PREVOST

**WARRANTY
BULLETIN**

WB14-08C

| SUBJECT : | GATEWAY MODULE REPLACEMENT | | |

Figure 4

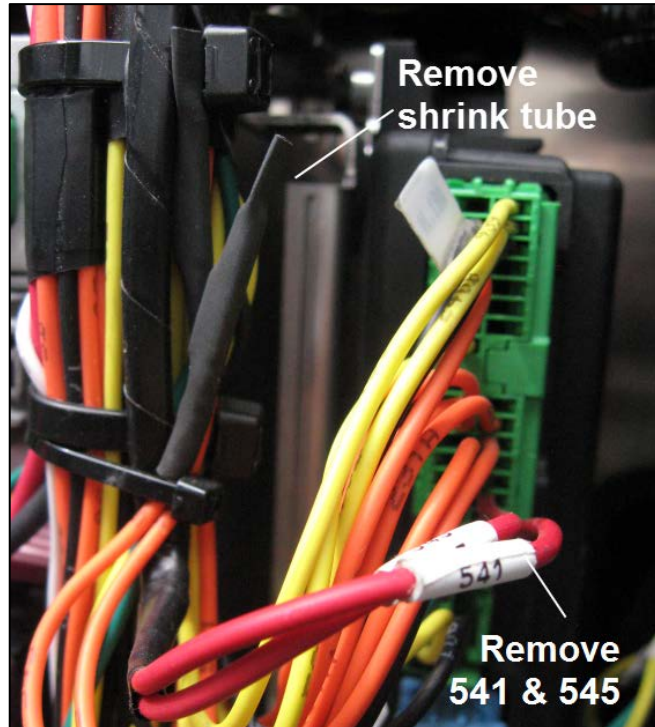
A4. Remove shrink tube and reconnect orange cables 541 and 545 from vehicle harness to VECU. (Fig 4)

- Connect 541 on JA1
- Connect 545 on JA2

Figure 11

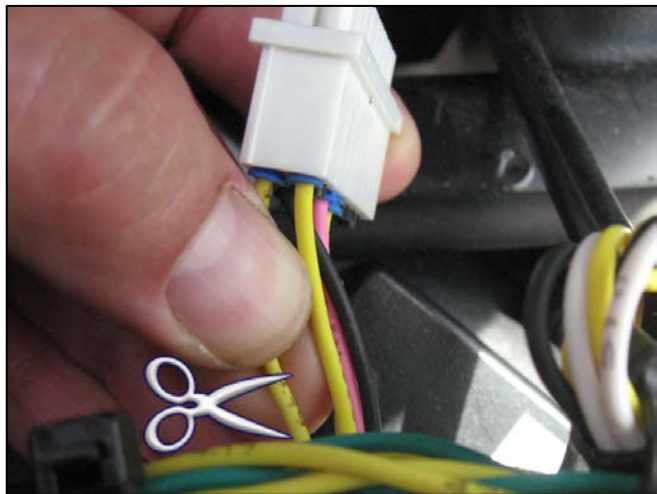
- C2. Unplug Connector to Gateway module A139.
- C3. Locate wire **439** at **pin 1** of Gateway Module A139. (Fig 11)
- C4. Cut about two inches away from connector. (Fig 11)

Figure 12

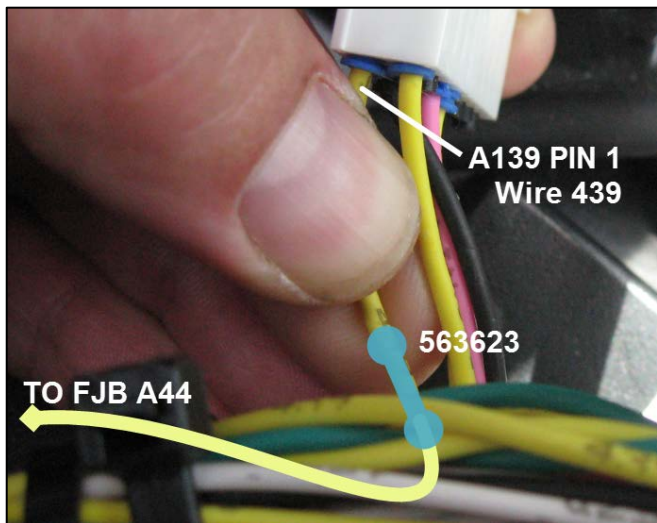
- C5. Run a new yellow 16ga **GXL** wire (560661 or equiv.) from A44 module in Front Junction Box to Gateway module.

Strip and connect to wire 439 coming out of gateway module connector pin 1 and new wire from front service compartment (FJB).

Use thermal shrink butt splice 563623. (Fig 12)

C6. Connect new wire to **A44:J1** using terminal 563692. (Fig 12)

Pin: 5 for H3-45 **VIP** and X3-45 **VIP**.

Pin: 6 for H3 **BUS** and X3-45 **BUS**
